File Number: 2-D-25-IH

Meeting: 4/16/2025
Applicant: Dave Madden
Owner: Antares LLC
District: Lonsdale Infill Housing Overlay District

Location: 3343 Divide St. **Parcel ID:** 81 P B 001
Zoning: RN-2 (Single-Family Residential Neighborhood)
Description:
New primary structure

Level III New Primary Structure

Title: SITE PLAN

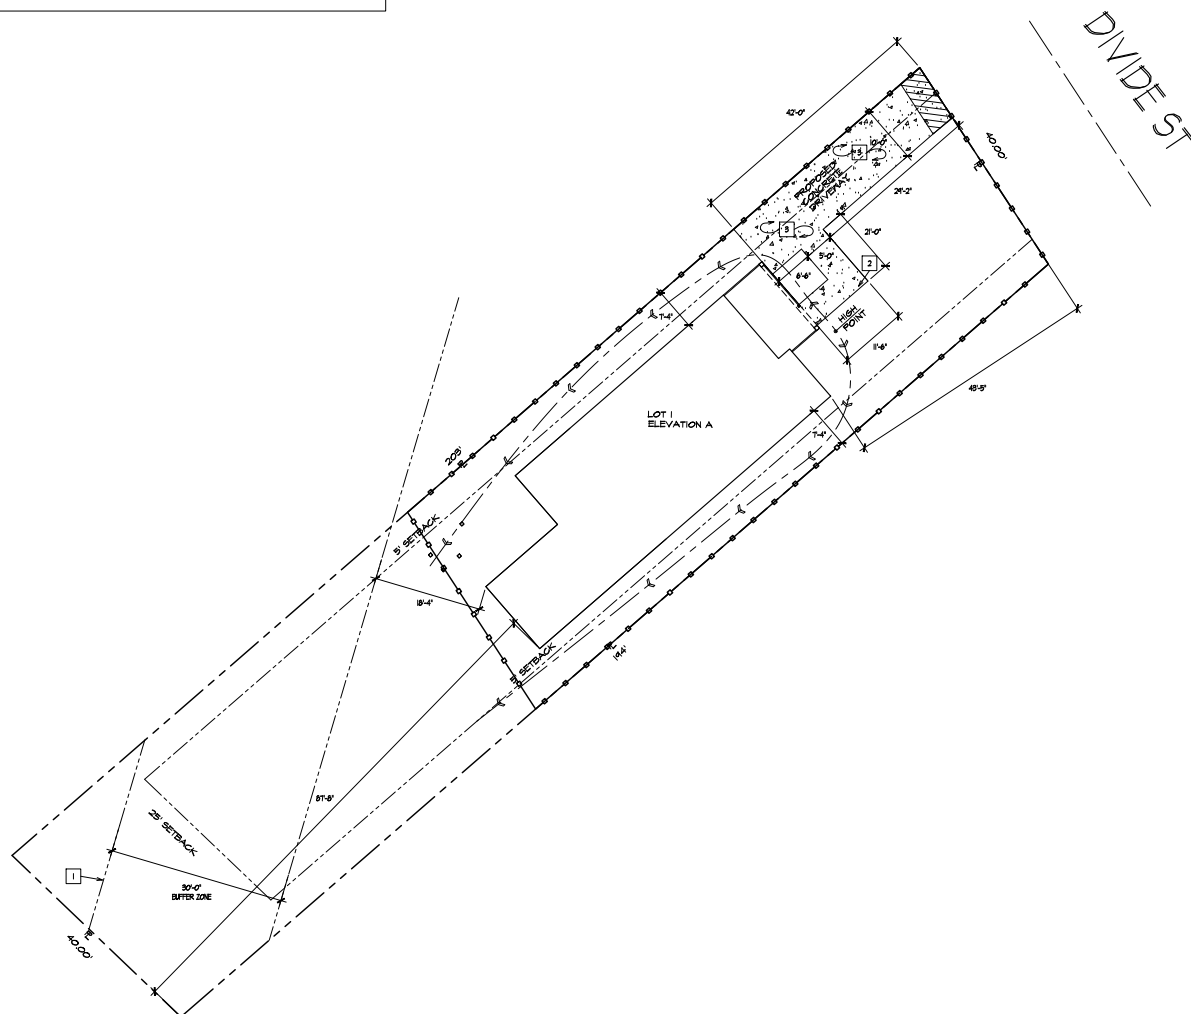
1. The house is proposed to be set 43'-5" front the front property line. The average front setback of the block is 41'. The adjacent houses are set significantly back, at 70' and 79'. The proposed front setback will be mirrored by the other houses and will be more in line with the block. The final site plan should be revised so that the front walkway connects to both the street and the driveway.

3. Infill Housing design guidelines recommend that on lots without alleys, new driveways should be at least 20' behind the front façade of the infill house with access limited to one lane between the street and the front façade. Parking can also be accessed from the rear street on through lots. Parking is a concrete pad located in front of the house and accessed via a driveway from Divide Street. Parking should be revised to avoid the front yard. The final site plan should meet City Engineering standards.

9. The final site plan should be revised to include a native or naturalized shade tree in the front and rear yards. Guidelines state that "Healthy trees that are outside the building footprint should be preserved." The remaining trees in the rear yard should be retained and indicated on the site plan, unless revisions to the parking location make removal necessary.

Staff recommends approval of Certificate 2-D-25-IH, subject to the following conditions: 1) the final site plan to meet City Engineering standards; 2) parking location to be revised to avoid the front yard; 3) the final site plan to include a walkway to the street; 4) foundation to be clad in stucco or parge-coated, and siding to be lap siding with an overlap, as opposed to Dutch lap, flush panel, or board-and-batten siding; 5) the final site plan to include a native or naturalized shade tree in the front yard and rear yard, and the remaining trees in the rear yard should be retained if at all possible.

ELEVATIONS

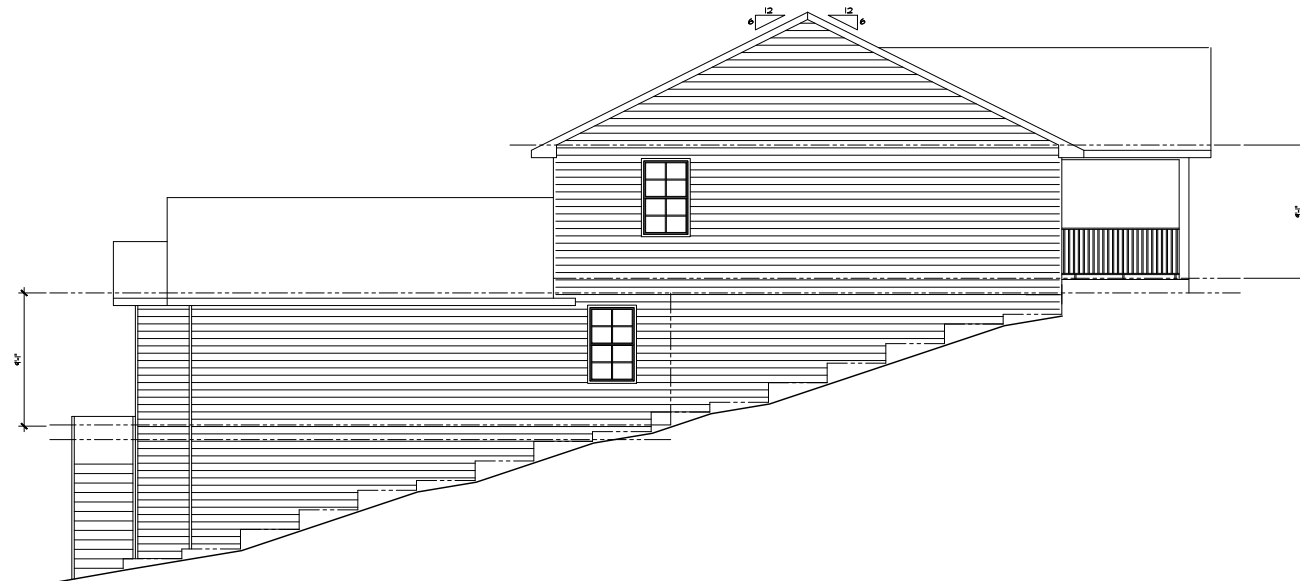
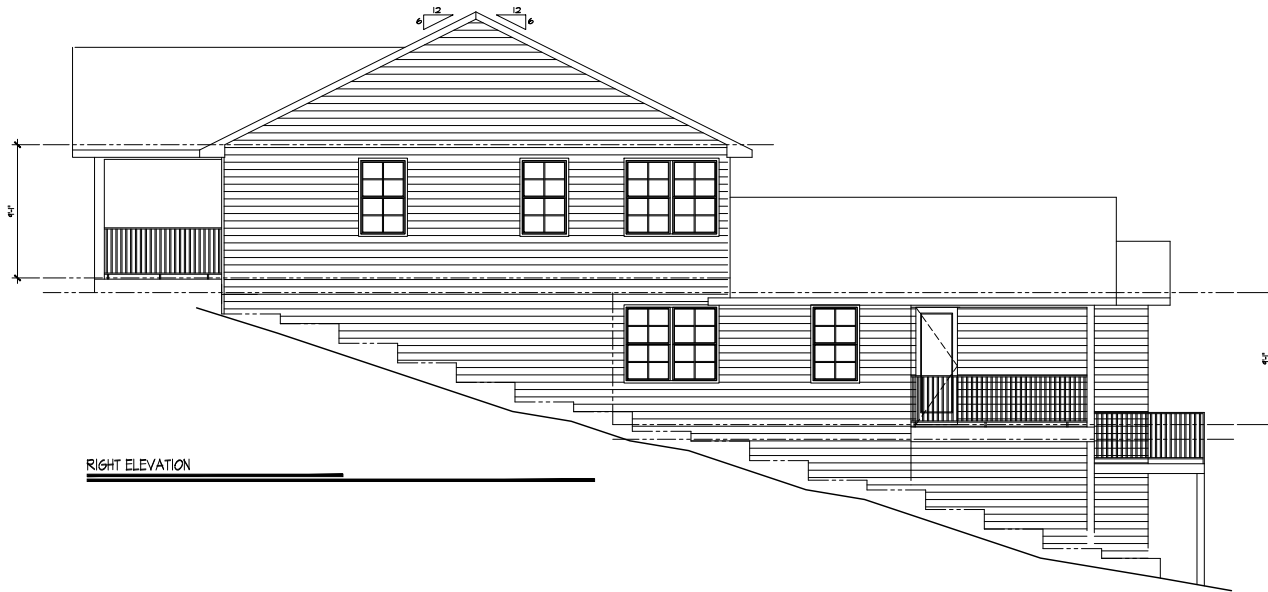
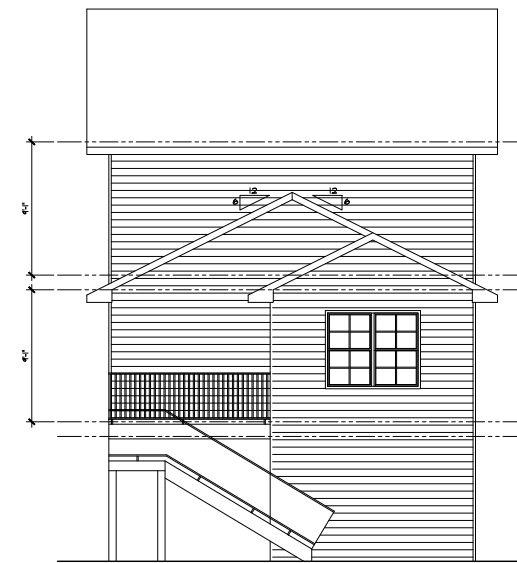
4. The one-story, three-bay façade on the front elevation is similar in scale and height to the context. No other houses on the block feature an additional basement-level massing, but those lots are not as steeply sloped.

5. The house features a half-length, 8'-8" deep front porch recessed under a projecting front-gable massing supported by two 8" square wooden posts, which meets the design guidelines.

6. Guidelines recommend window and door styles be similar to historic houses on the block, with similar placement and ratio of solid to void. The 4/4 single-hung windows are compatible with the 6/6 single-hung windows on most houses in the block, and all elevations except the left elevation feature a sufficient ratio of solid to void. The left elevation will be minimally visible from the street due to small setbacks, but it features large swaths of blank siding, particularly on the rear massing. The Board should discuss whether an additional window on the left elevation of the rear massing is necessary.

7. The 6/12 roof pitch matches guidelines and the neighborhood context. The design benefits from the complexity of the trim and partial cornice returns, which should be retained.

8. The asphalt shingles and vinyl horizontal siding meet the design guidelines. The foundation appears to be a concrete block, which should be clad in stucco or parge-coated to meet the design guidelines. The final siding material should be lap siding with an overlap, as opposed to Dutch lap, flush panel, or board-and-batten siding.
